City of Portland, Maine – Building or Use Permit Application 389 Congress Street, 04101, Tel: (207) 874-8703, FAX: 874-8716

Location of Construction: 59 State St. 04101		Owner: State Way Apts. Inc.		Phone: 774-3683		Permit No: 000404	
Owner Address: 658 Congress St. 04101		Lessee/Buyer's Name:		Phone:		BusinessName:	
Contractor Name: Geoffrey Rice		Address: 658 Congress St 04101		Phone:		Permit Issued:	
Past Use: Multi Family		Proposed Use: Same		COST OF WORK: \$70,000.00		PERMIT FEE: \$ 444.00	
Proposed Project Description: Replacement of Elevator		Signature: <i>[Signature]</i>		FIRE DEPT. <input checked="" type="checkbox"/> Approved <input type="checkbox"/> Denied		INSPECTION: Use Group <i>A2</i> Type <i>3B</i>	
				PEDESTRIAN ACTIVITIES DISTRICT (P.A.D.)		Signature: <i>[Signature]</i>	
Action:		Approved		<input type="checkbox"/>		Zone: <i>A-C</i> CBL: 044-B-047	
		Approved with Conditions:		<input type="checkbox"/>		Zoning Approval: <i>[Signature]</i> for elevator	
		Denied		<input type="checkbox"/>		Special Zone or Reviews: <input type="checkbox"/> Shoreland <i>only</i> <input type="checkbox"/> Wetland <input type="checkbox"/> Flood Zone <input type="checkbox"/> Subdivision <i

BASEMENT LEVEL PLAN 1/2" = 1'-0"

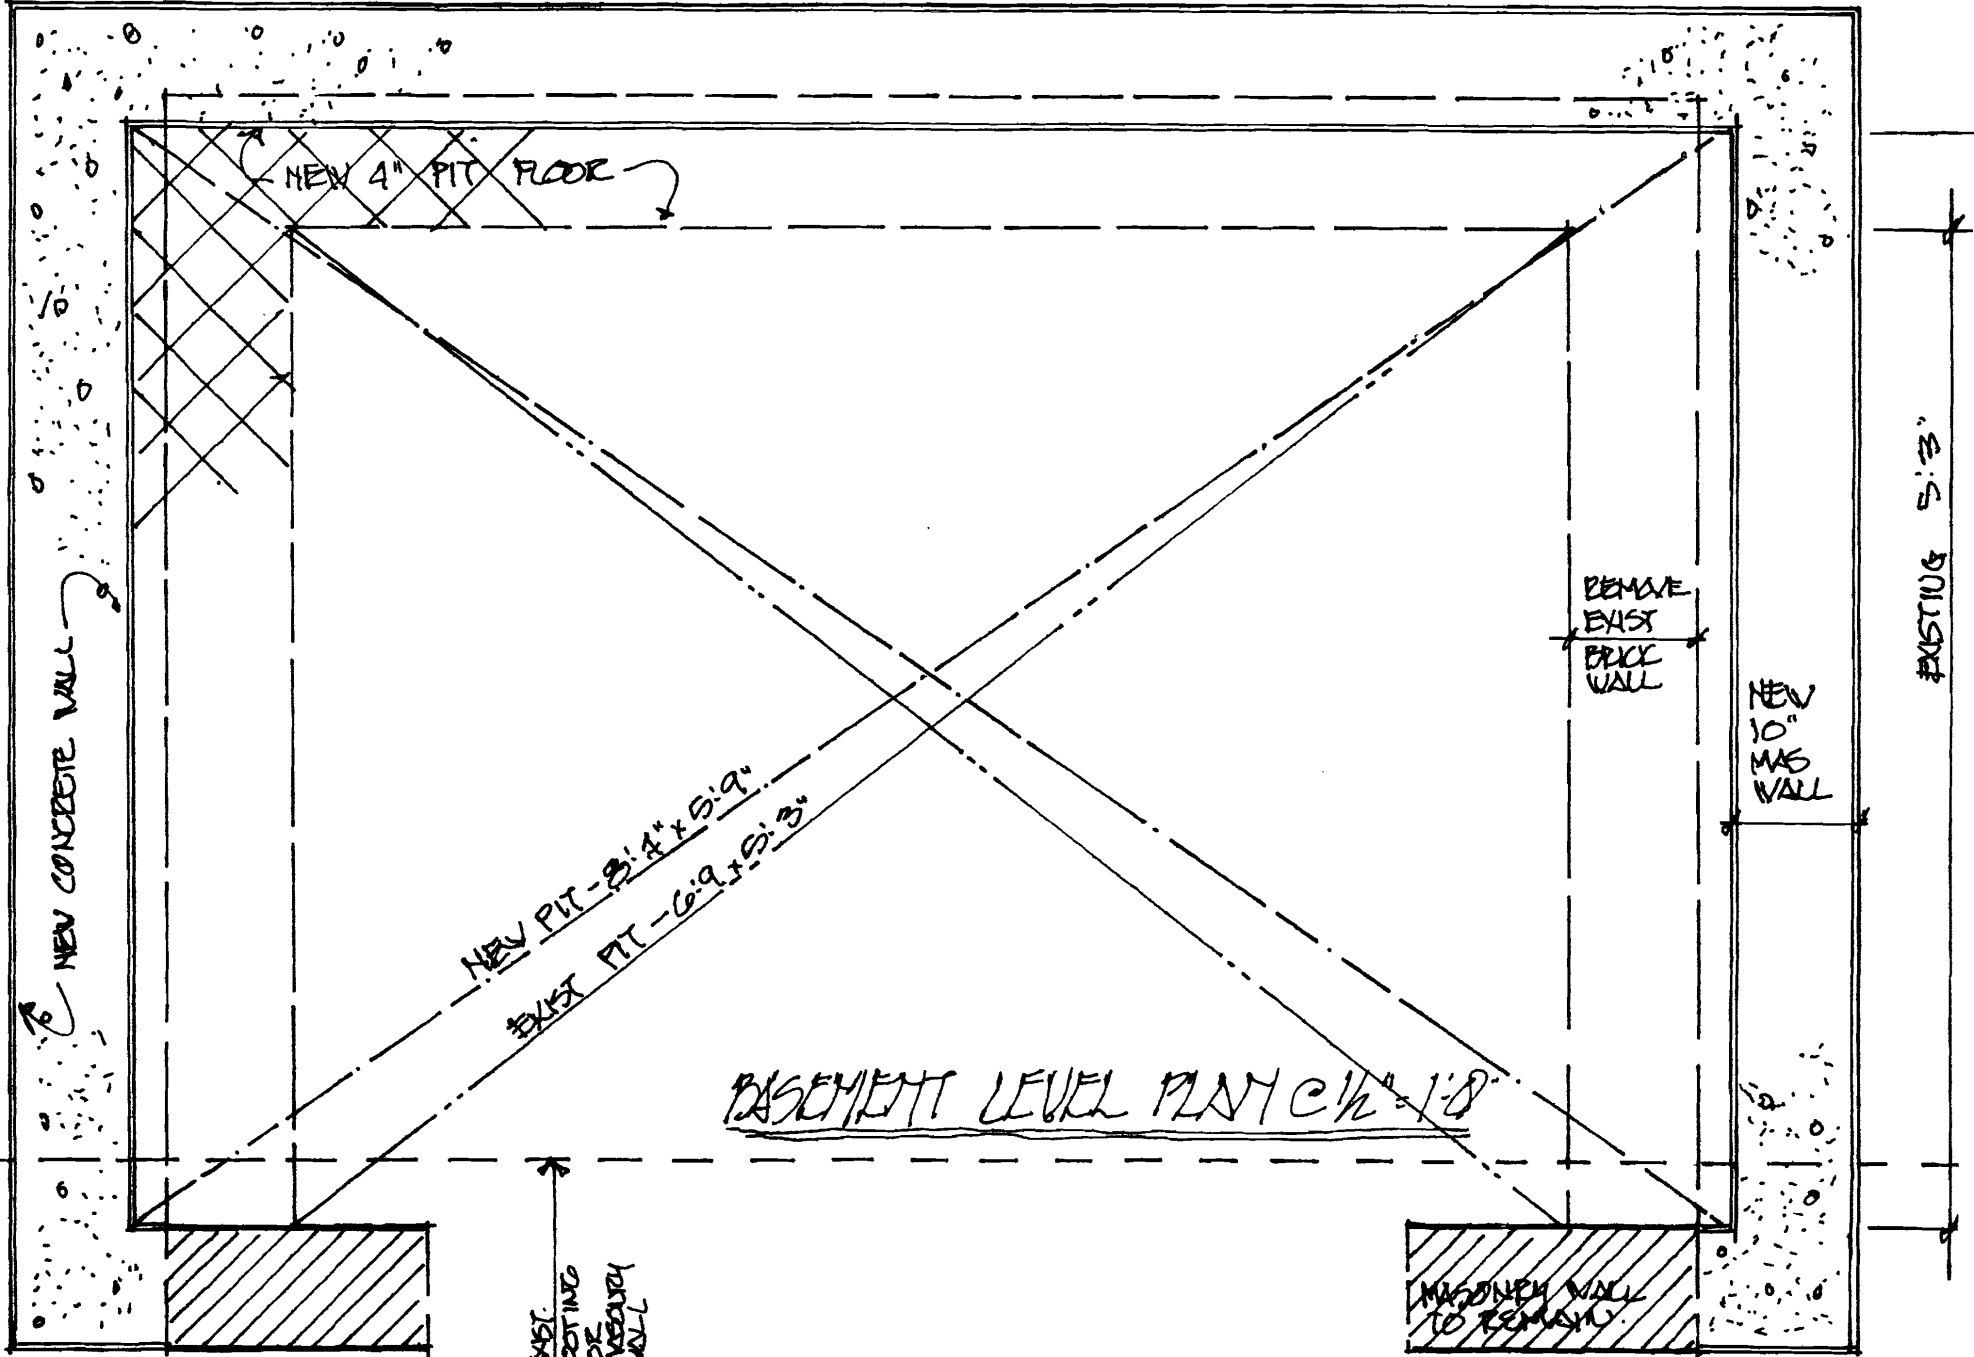
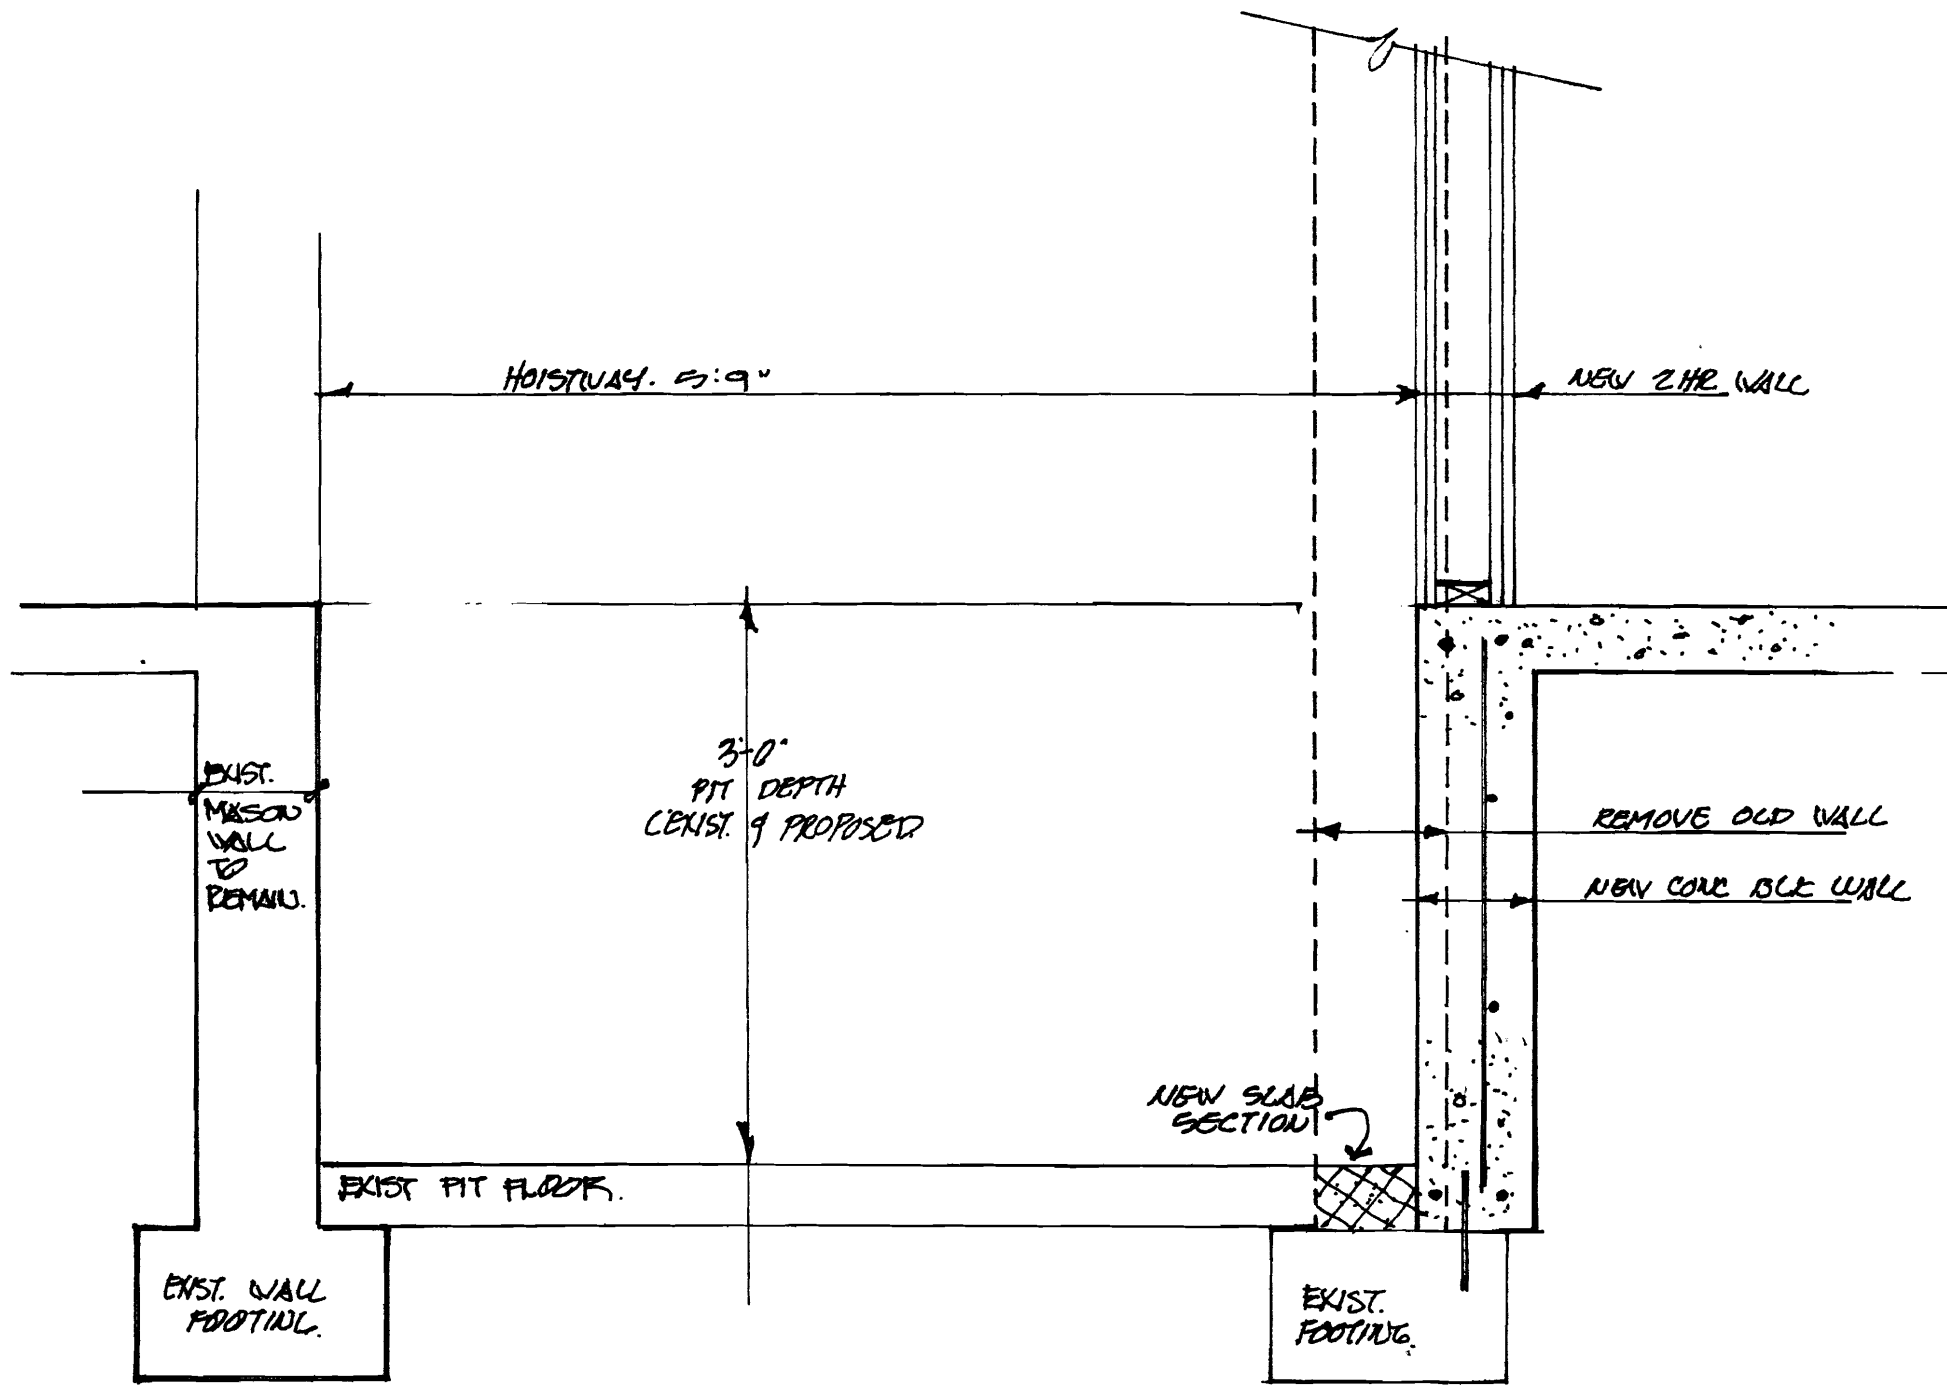
36. *The proposed elevator shall be in a two hour fire rated shaft.*

37. *Any penetration within this shaft shall meet the two hour rating.*
